# THE BAGGAGE HOUSE at **UNION STATION**

BAGGAGE HOUSE at UNION STATION A PRIVATE RESIDENCE

**ARB SUBMITTAL 4/30/18**

REFERRING TO THE EXISTING SOUTH ELEVATION:

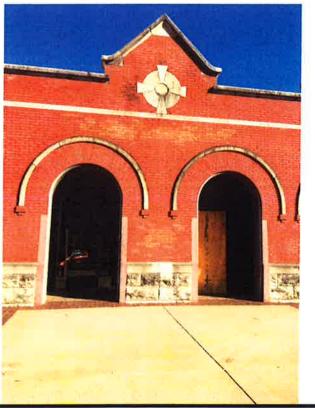
THE TWO FULL HEIGHT ARCHED OPENINGS ON THE EAST END WERE FORMERLY THE BANK ENTRANCE AND RECESSED ATM MACHINE. ALL OF THIS EQUIPMENT AND ENTRY DOORS AND GLAZING WILL BE REMOVED. REFER TO SHEET A3.1.

DRAWING TITLE: **ELEVATION -EXISTING**

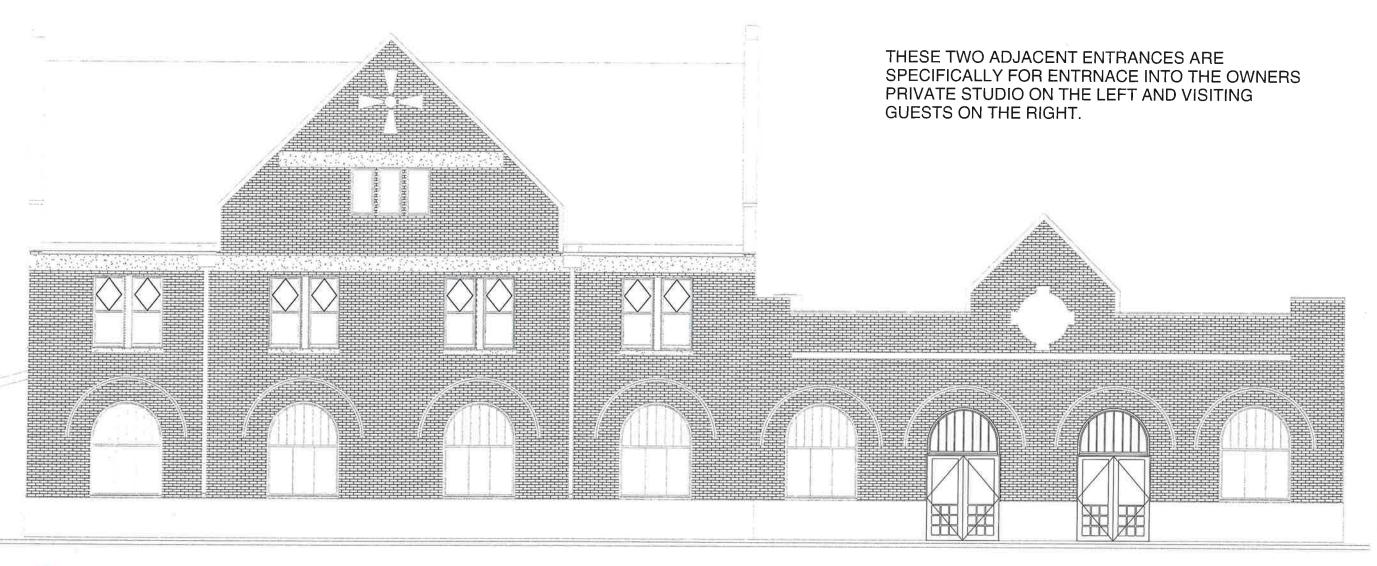
THE OWNER REQUESTS
CONSIDERATION OF INCLUDING THIS
STAINED GLASS TRANSOM SECTION
OVER THE LEFT MOST NEW DOORS. THIS
DESIGN HAS A SIGNIFICANT AND
PERSONNAL MEANING TO MR. TEUTON.
THIS WILL ALSO DENOTE THE ENTRANCE
TO MR. TEUTON'S STUDIO.

DRAWING TITLE: SOUTH ELEVATION -NEW

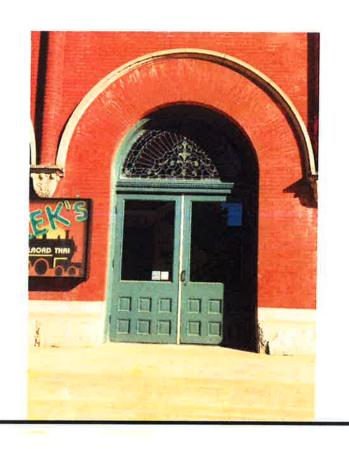
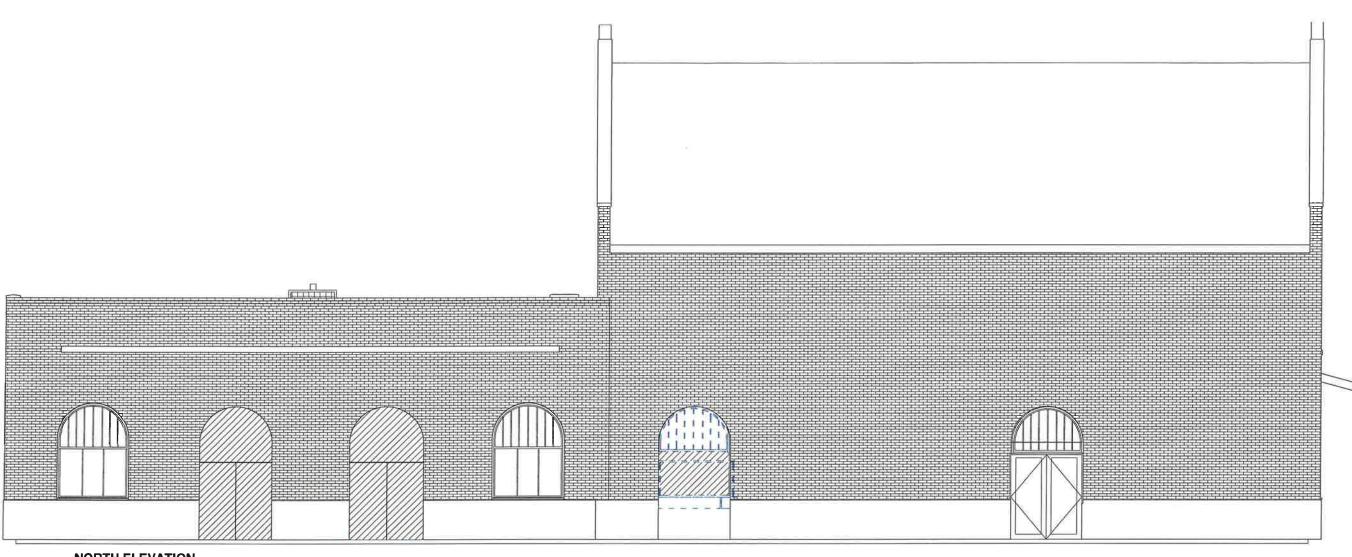
THE TWO FULL HEIGHT ARCHED OPENING WILL BE FITTED WITH WOOD AND GLASS DOORS AND ARCHED TRANSOM TO MATCH THE RAISED PANEL DOORS FOUND ON THE MAIN BUILDING OF UNION STATION.

DRAWING TITLE: NORTH ELEVATION -EXISTING

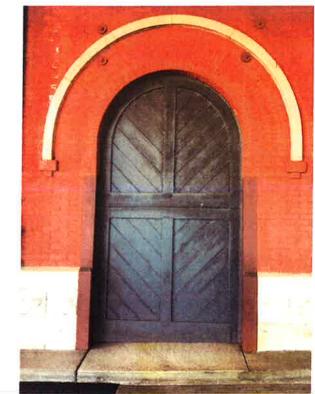
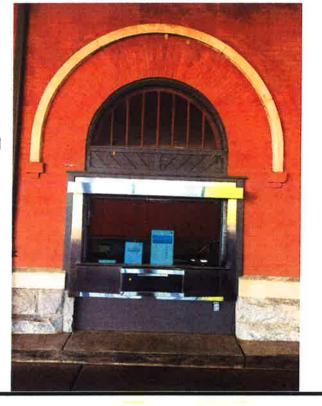
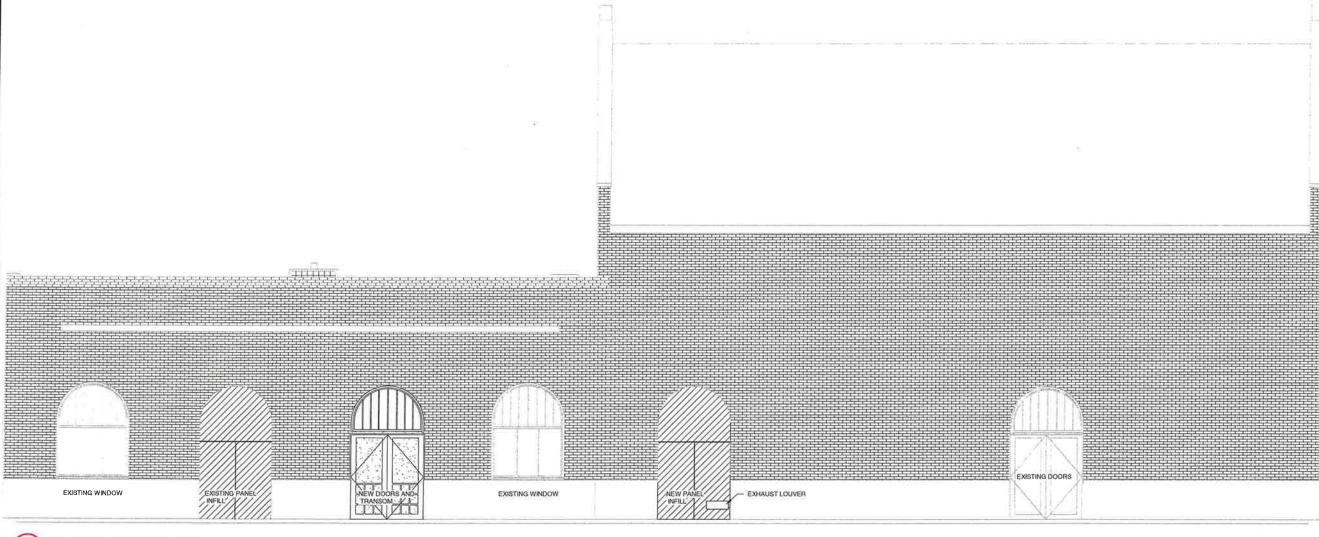
THE DRIVE UP TELLER WINDOW IS BEING REMOVED. THE WESTERN MOST WOOD PANEL CLOSURE WILL BE REMOVED FOR RELOACTION IN THE DRIVE UP TELLER WINDOW OPENING.

DRAWING TITLE: NORTH ELEVATION -NEW

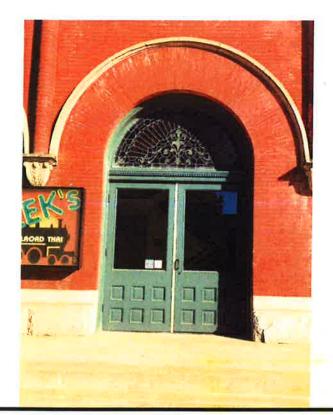
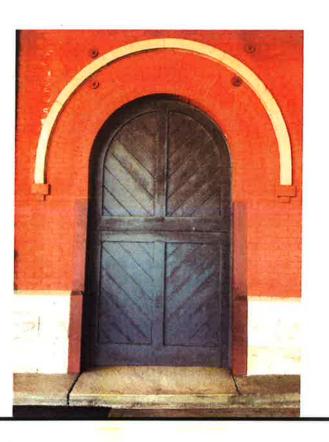
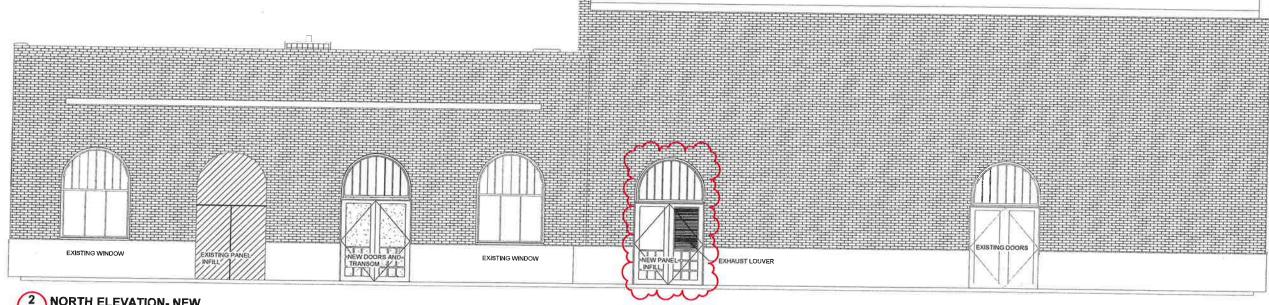
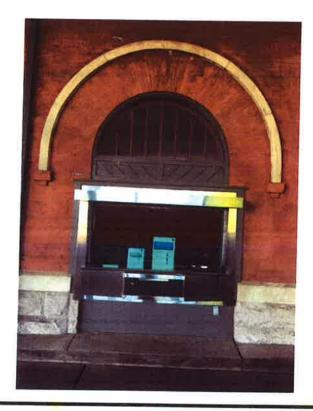
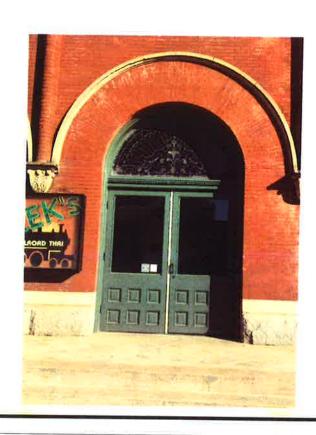
THE WOOD PANEL CLOSURE REMOVED SHALL BE INSTALLED IN THE LOCATION PREVIOUSLY HELD BY THE DRIVE UP TELLER WINDOW. A SMALL OUTSIDE AIR LOUVER WILL BE INSTALLED AND A HOSE BIBB. THE LOCATION WHERE THE WOOD PANEL WAS REMOVED WILL BE FILLED BY THE SAME MATCHING DOOR UNITS AS WILL BE FOUND ON THE SOUTH ELEVATION.

A4.1A

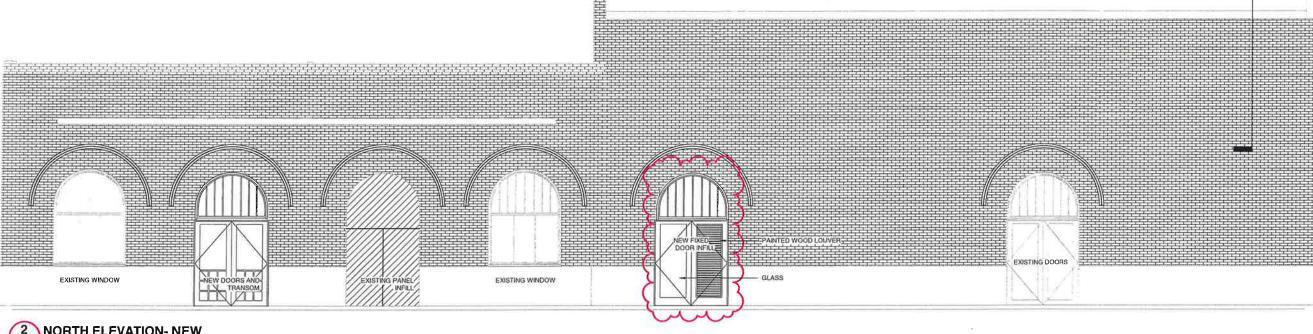
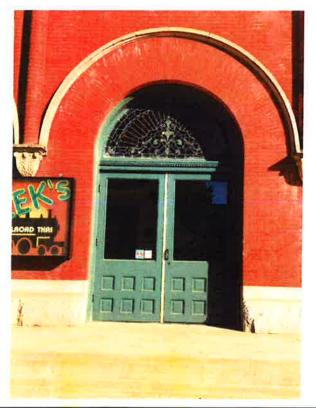
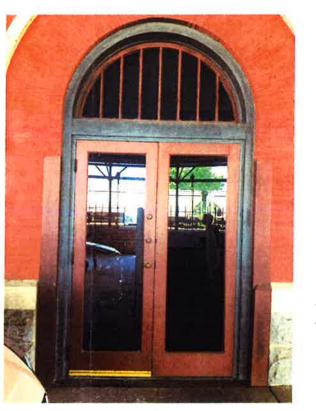
WHERE THE TELLER WINDOW IS TO BE REMOVED, WE ASK FOR AN AMENDMENT OR REVISED SUBMITTAL FOR THIS OPENING. THE OWNER DESIRES A LOUVER TO BRING IN AND EXHAUST AIR FROM A ROOM ON THE FIRST FLOOR. THIS A LOW VOLUME PIECE OF EQUIPMENT. WE PROPOSE TO MODIFY ONE OF THE NEW DOORS TO ACCOMMODATE THIS DEVICE WITH A PAINTED WOOD LOUVER. THE FILTERING WILL BE ON THE INSIDE. THE EXISTING TRANSOM LIGHT WILL BE LEFT IN PLACE.
